December 16, 2015
BOARD OF COUNTY COMMISSIONERS
ORANGE COUNTY, FLORIDA
Addendum No. 3, IFB Y16-718-CC

MILDRED DIXON ACTIVITY CENTER HVAC REPLACEMENT

Orange County Mildred Dixon Activity Center HVAC Replacement

A HVAC DEMOLITION PLAN
SCALE: 1/4" = 1'-0"

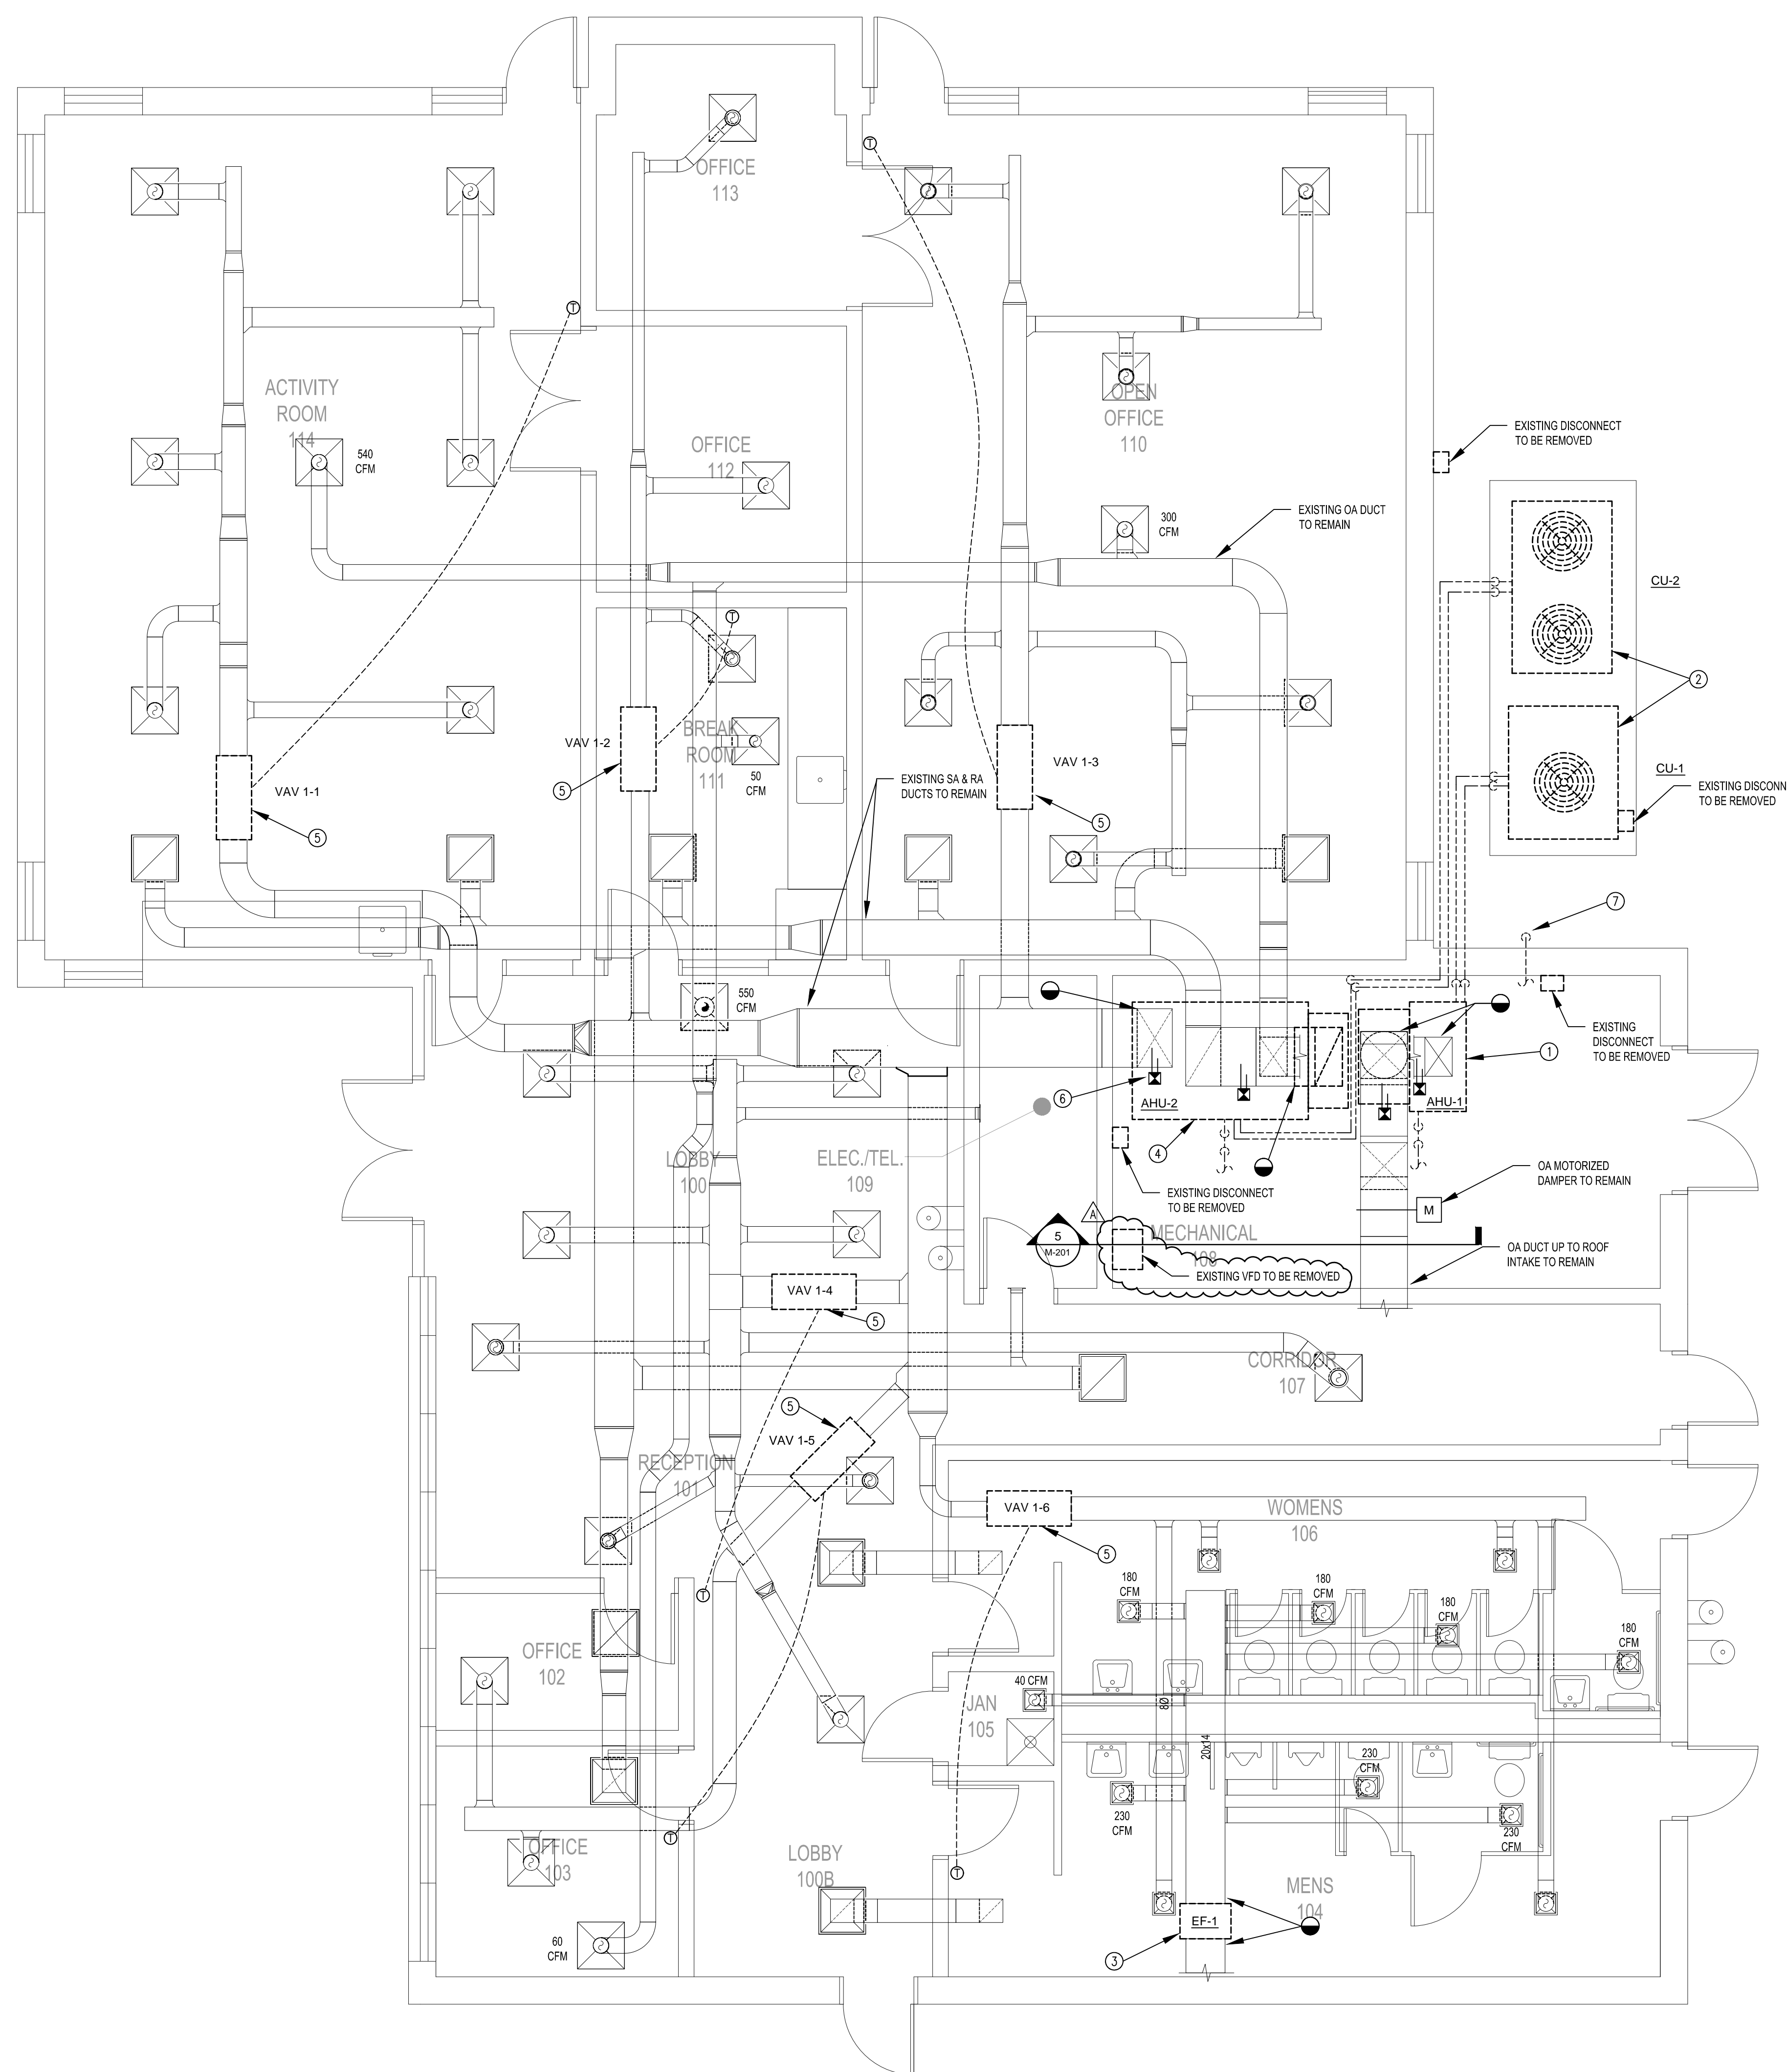
Sheet	Description of Revision
M-001	-Added HVAC General Note #20
M-101	-Revised Key Note #7 -Located existing VFD to be replaced
M-102	-Revised Key Note #5 -Revised condensate lines to be two lines, one per AHU -Located new VFD to be provided
M-201	-Added Variable Frequency Drive to note #6 -Added note #8 to Split DX Indoor AHU Schedule -Revised Detail #4 for above ground refrigerant piping
E-101	-Added new Variable Frequency Drive to Key Note #7 and located new VFD and disconnect to electrical plan -Added Key Note #8 for HOA VFD control - Added Key Note #9 for new VFD coordination with existing building management system (Johnson Controls)

6. EXISTING DUCT SMOKE DETECTORS TO REMAIN (TYP OF 4).
 7. REMOVE EXISTING CONDENSATE DRAIN LINES. CAP AND ABANDON IN PLACE THE PORTION OF THE CONDENSATE DRAIN LINE ROUTED UNDER FOUNDATION.

A HVAC NEW WORK PLAN
SCALE: 1/4" = 1'-0"

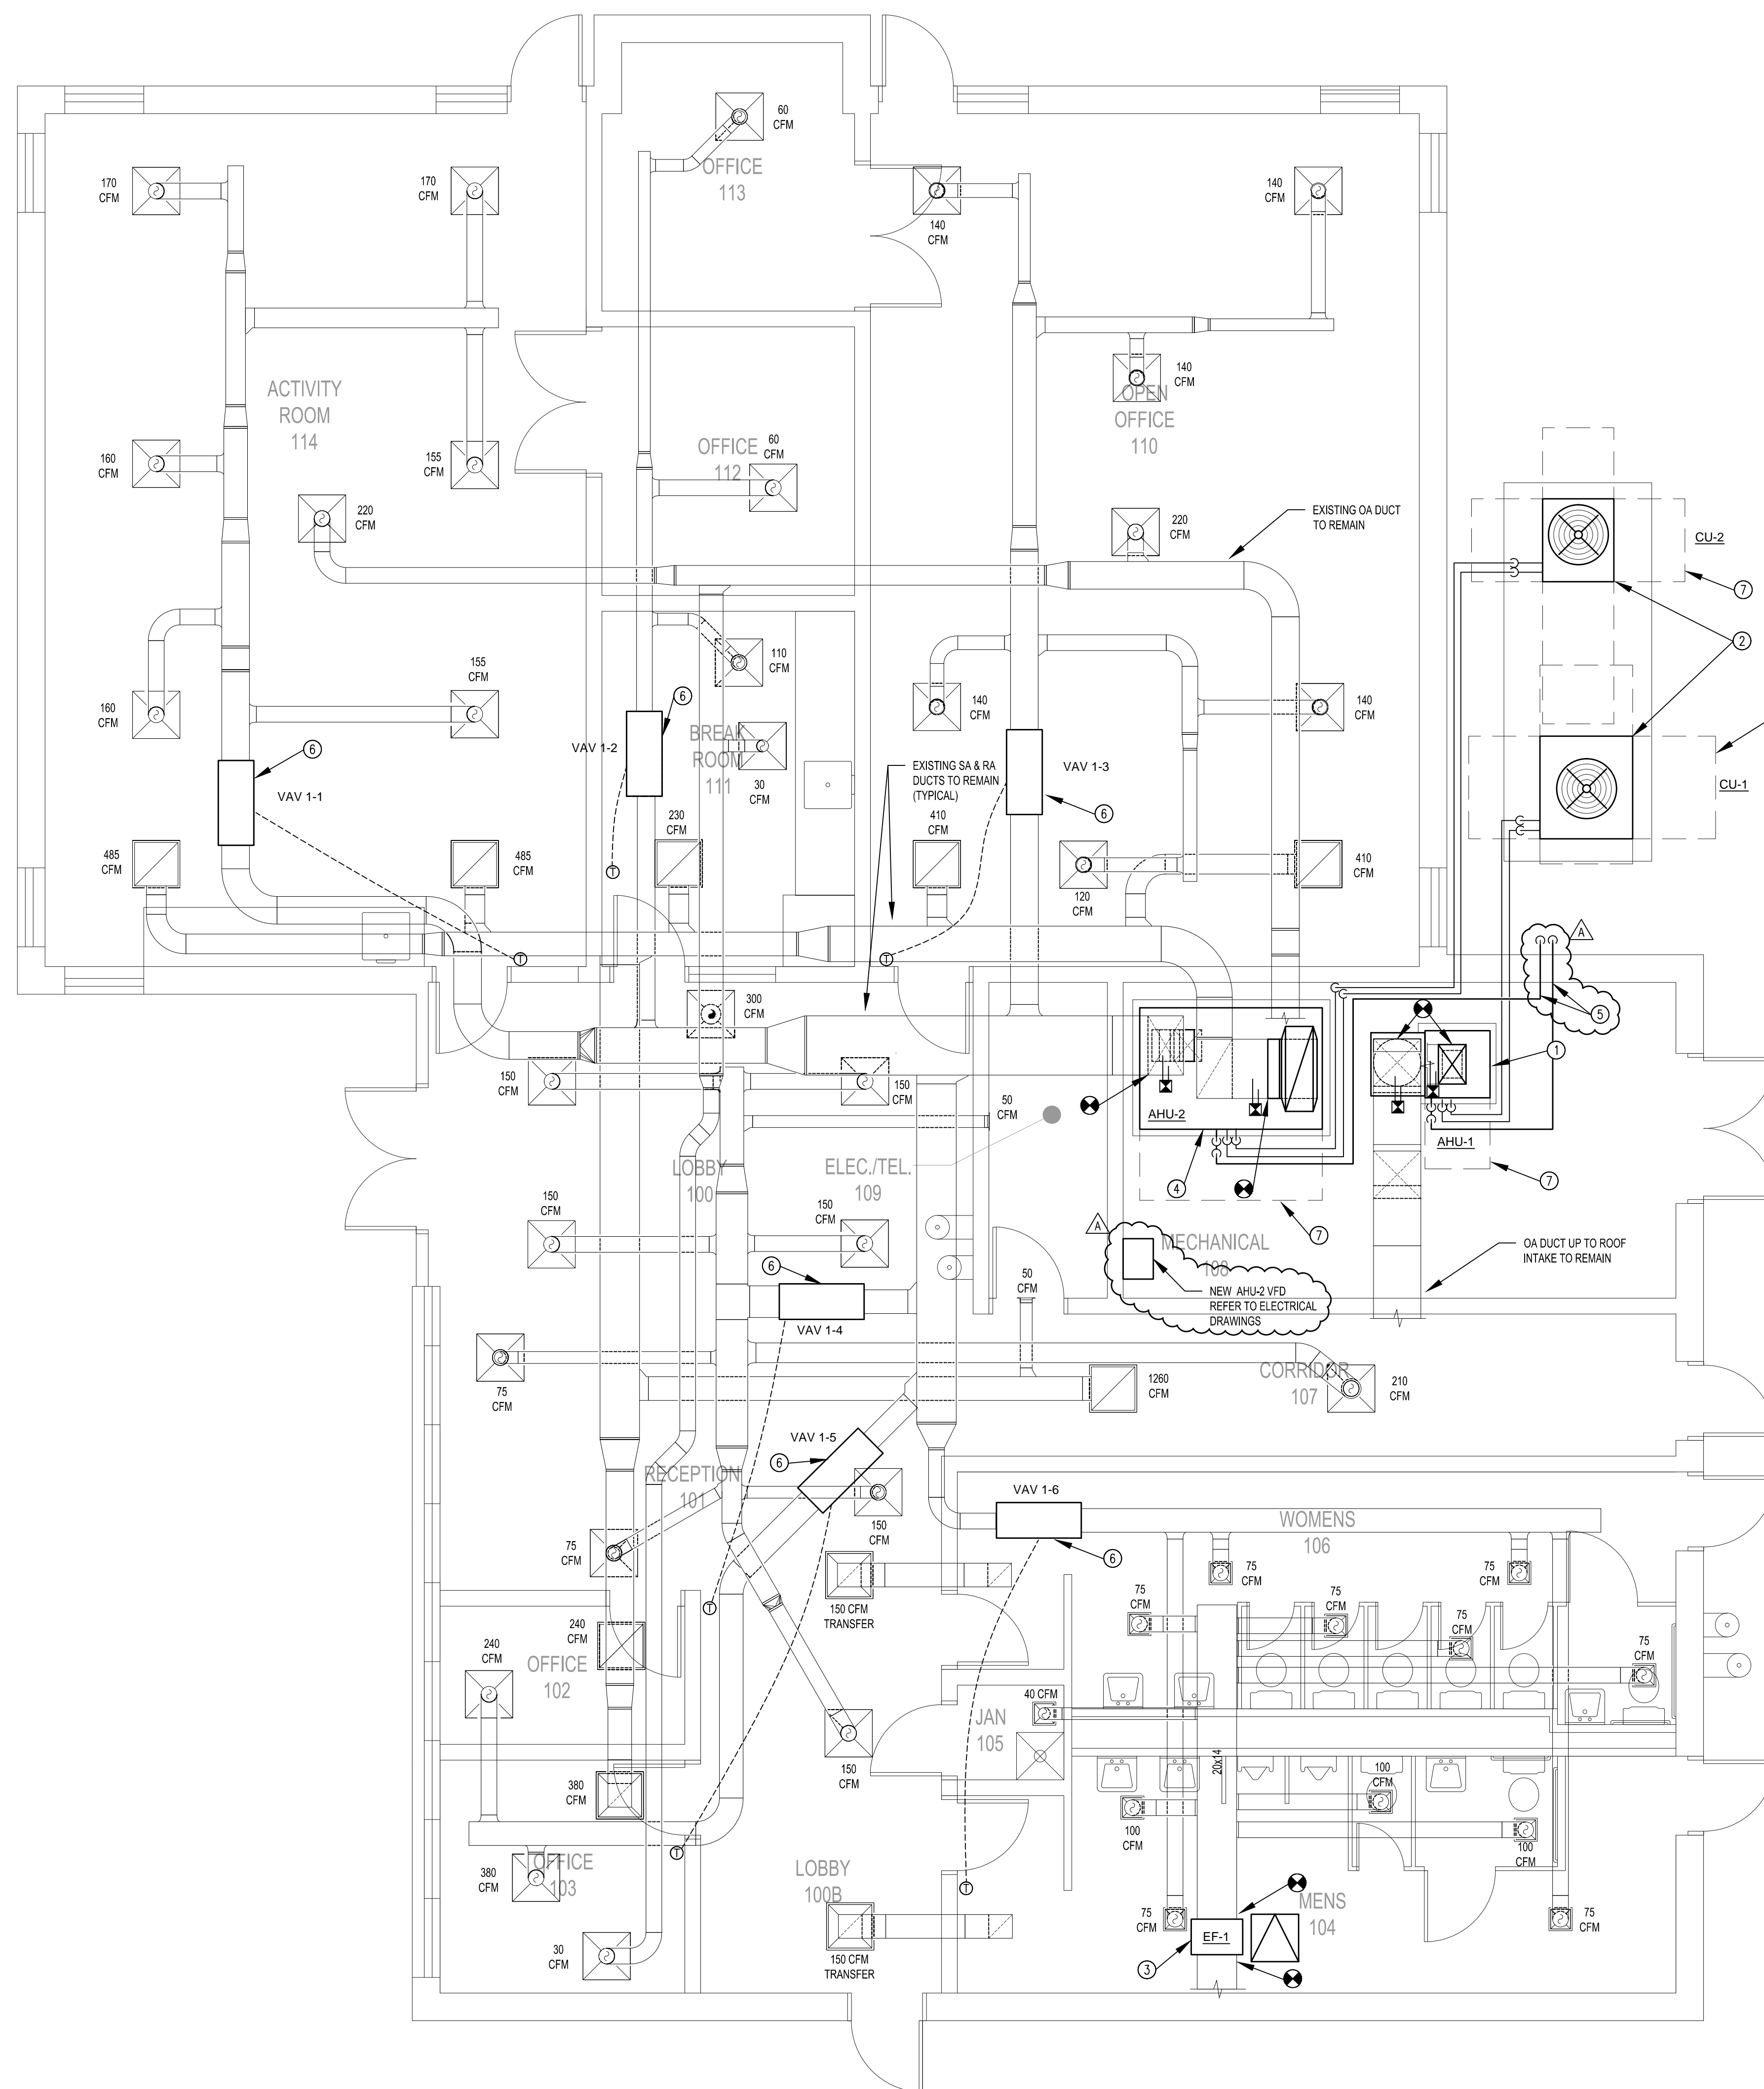
- ROUTE NEW CONDENSATE LINES THRU WALL TO EXISTING DRYWELL. PROVIDE NEW FITTERS AND SLOPE DRAIN LINES TO DRYWELL.
 - PROVIDE NEW VARIABLE AIR TERMINAL UNITS WITH ELECTRIC HEAT (TYPICAL OF 6). CONNECT TO EXISTING SA DUCT. PROVIDE NEW THERMOSTAT AT LOCATION SHOWN ON PLAN. REFER TO ELECTRICAL DRAWINGS FOR NEW POWER REQUIREMENTS.
